# DEVELOPMENT REVIEW BOARD REPORT

CASE NUMBER/ PROJECT NAME	<b>11-DR-2005</b> <b>Lost Dog Wash Trailhead</b>		
LOCATION	12601 N. 124th St., north of the Cactus Road alignment		
REQUEST	Request approval for site plan and elevations for the Lost Dog Wash Trailhead entry gate, lighting, structures and related roadway improvements on 124th Street, 122nd Street and Wethersfield Drive.		
OWNER	City of Scottsdale 480-312-7869	ENGINEER	Entranco Inc 602-889-7000
ARCHITECT/ DESIGNER	Weddle & Gilmore Architects 480-517-5055	APPLICANT/ COORDINATOR	Phillip Weddle Weddle & Gilmore Architects 480-517-5055
BACKGROUND	<p><b>Zoning.</b></p> <p>The site is zoned R1-43 ESL. The Lost Dog Wash Trailhead is the second of nine proposed trailheads to provide passive recreational public access to the McDowell Sonoran Preserve. The Sunrise Trailhead (Case 91-DR-2003, then known as Hidden Hills Trailhead) was approved by the Development Review Board on February 5, 2004.</p> <p><b>Context.</b></p> <p>The site is located at the north end of 124<sup>th</sup> St., north of the Cactus Road Alignment and east of Ancala East, Phase 3. The trailhead provides access to the McDowell Sonoran Preserve to the north of th

7 FEB 2005 PM 00L  
 WEDDLEHUGHMORE  
 SCOTTSDALE, ARIZONA  
 SITE PLAN

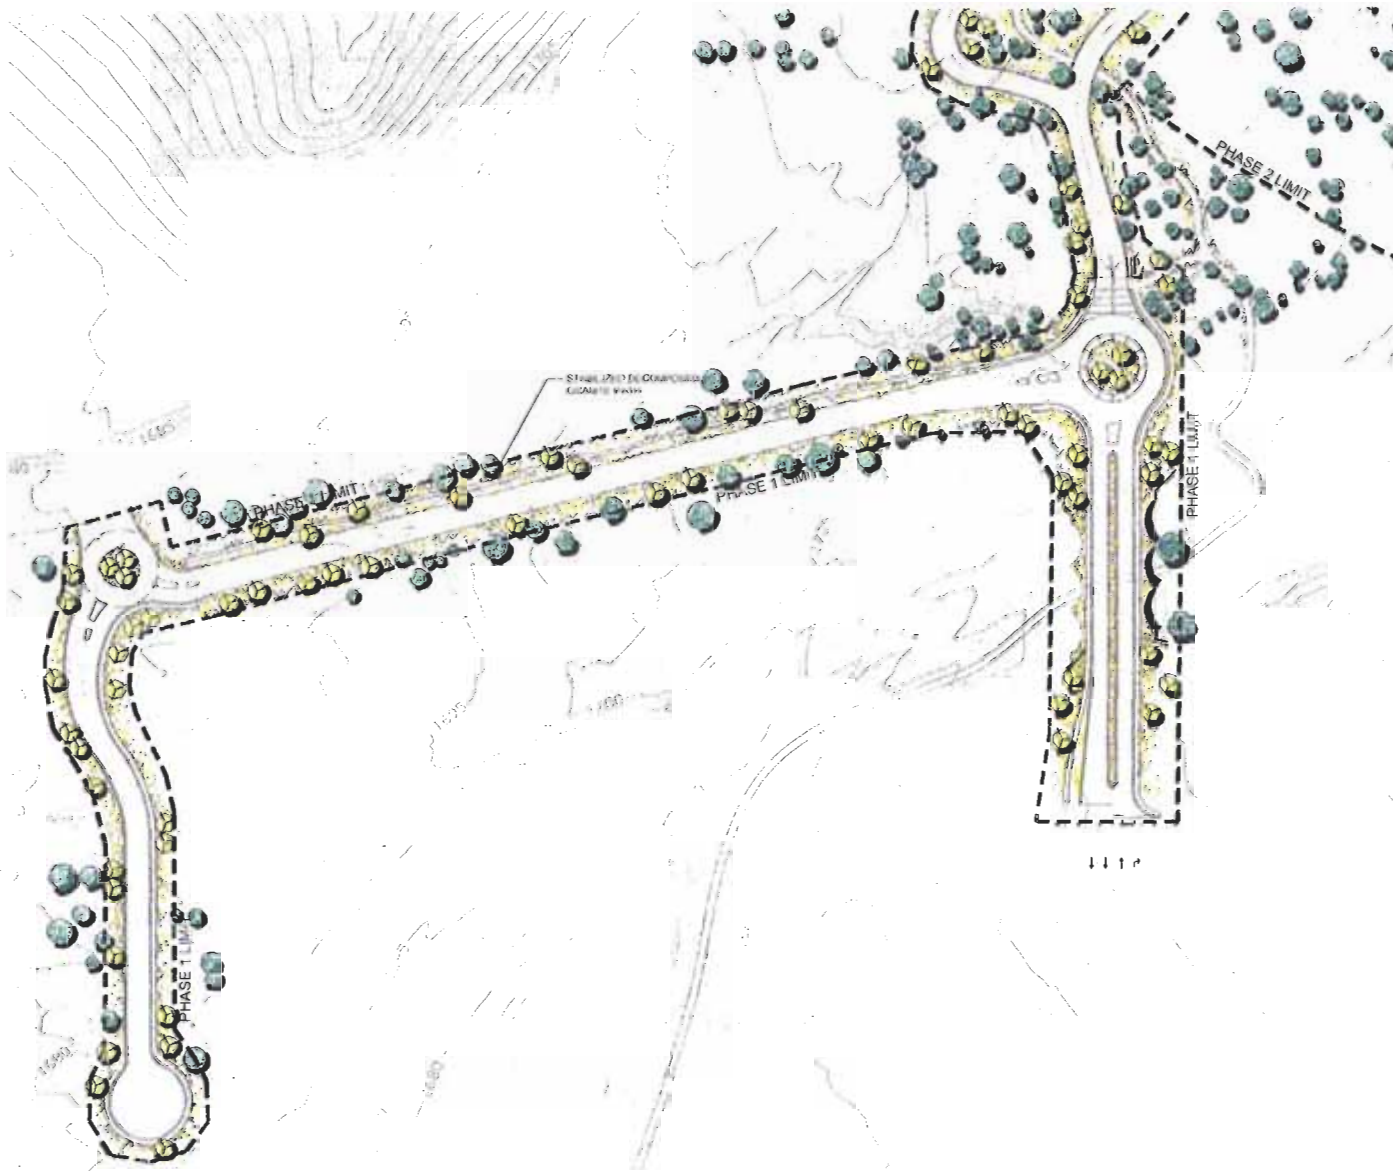
- b. The location and configuration of all site improvements shall be constructed to be consistent with the Site Plan sheet labeled DRB-2 submitted by Weddle Gilmore Architects with a city received date of 2/8/2005.

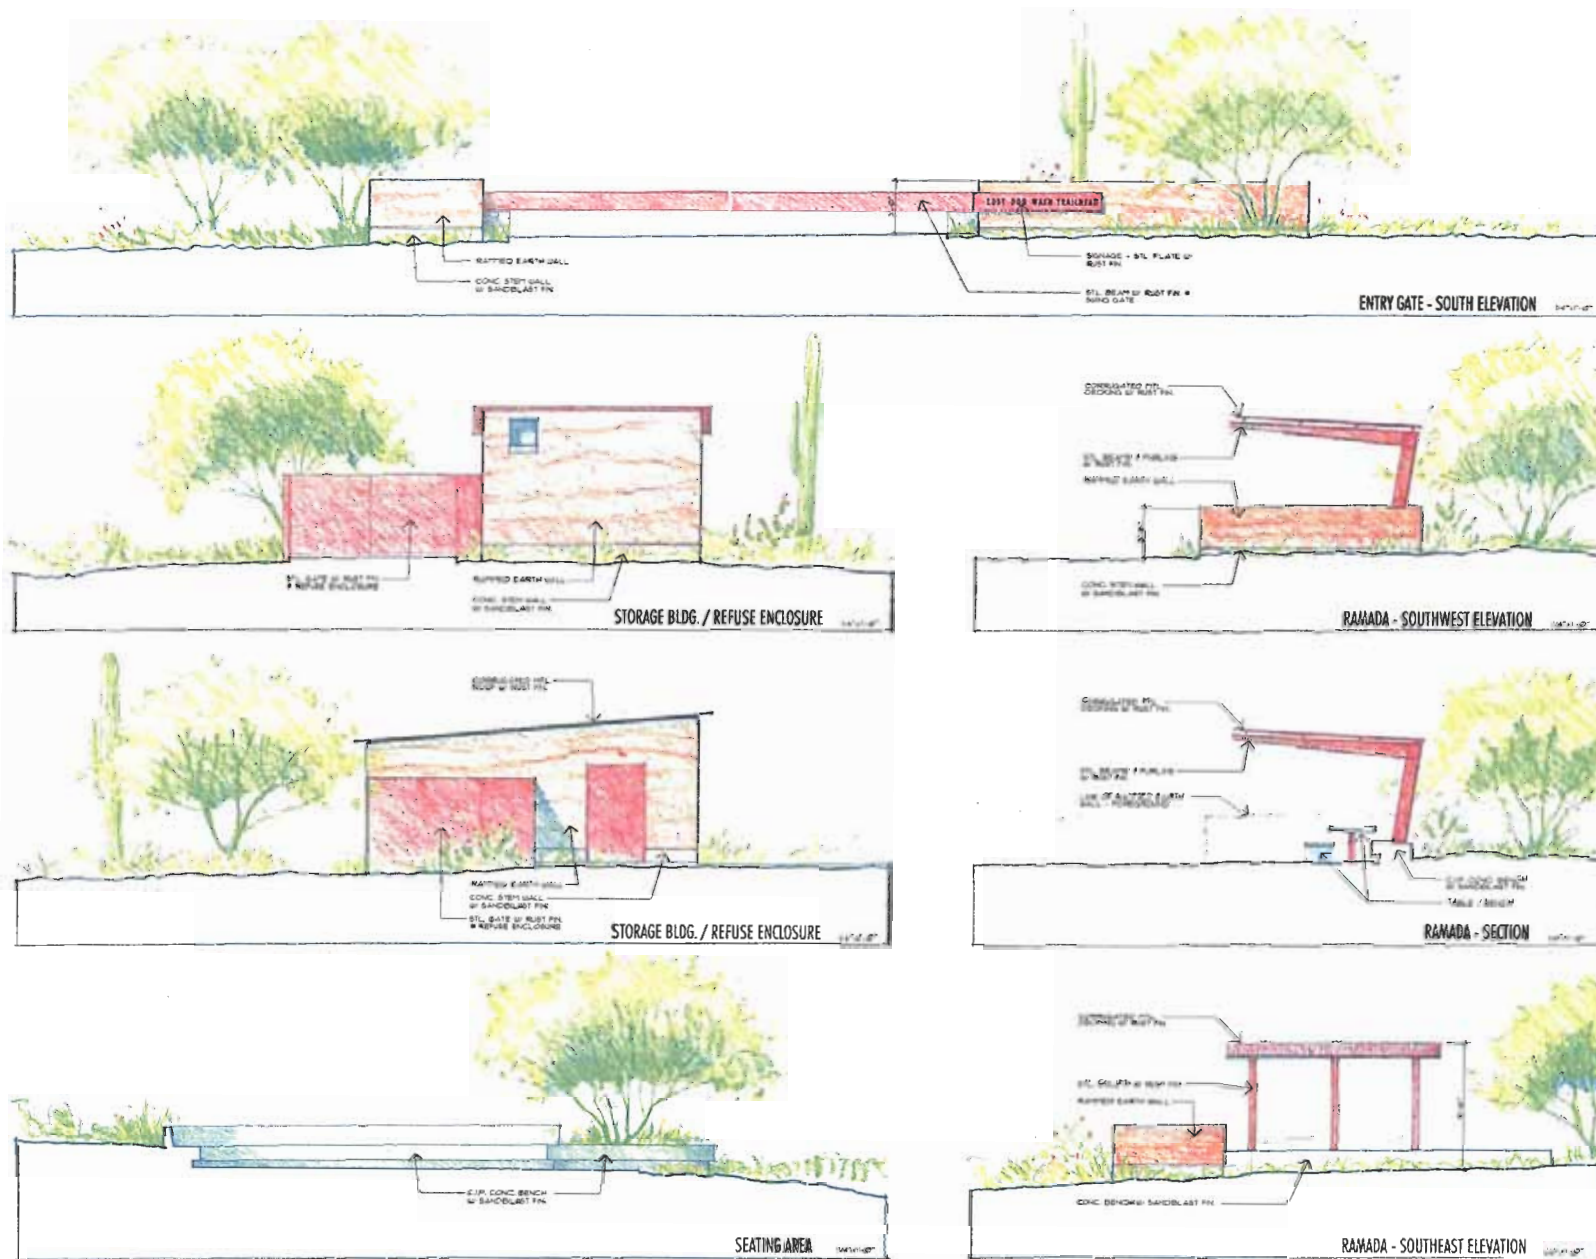
- c. Landscaping, including plant types, size, and location of materials shall be installed to be in general conformance with the Conceptual Landscape Plan sheets L-1.1 and L-1.2 submitted by Weddle Gilmore Architects with a city received date of 2/8/2005 except that there will be no landscape median along 124<sup>th</sup> Street.

ELEVATIONS

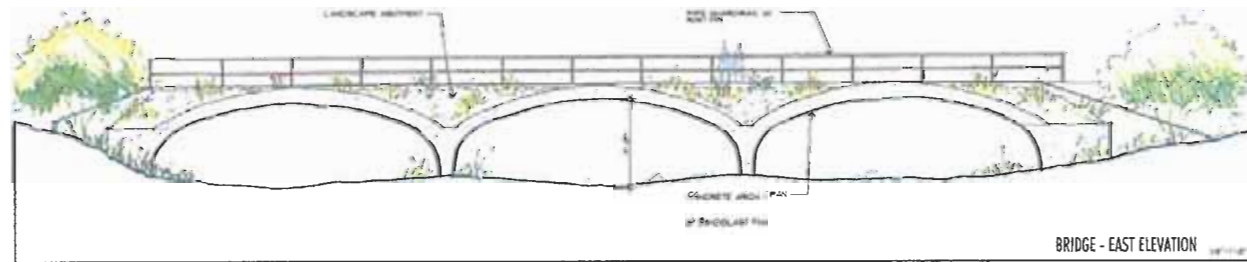
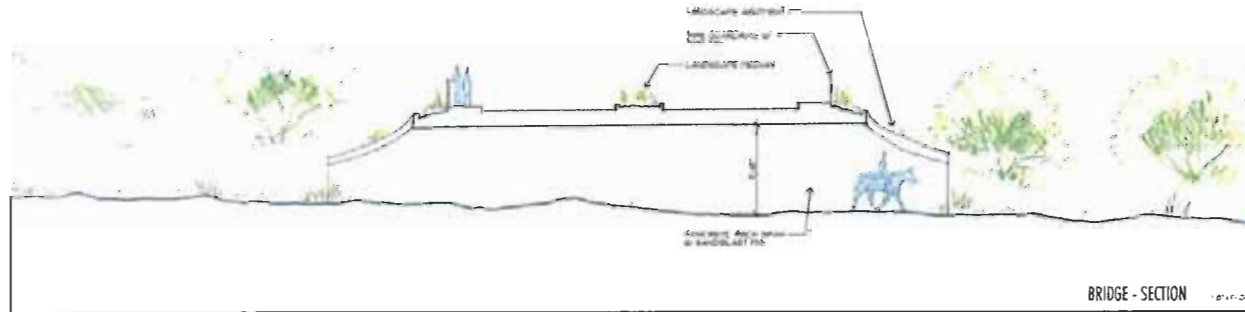
- a. Architectural elements, including dimensions, materials, form, color, and texture, shall be constructed to be consistent with the Elevation sheets labeled DRB-4 and DRB-5 submitted by Weddle Gilmore Architects with a city received date of 2/8/2005.
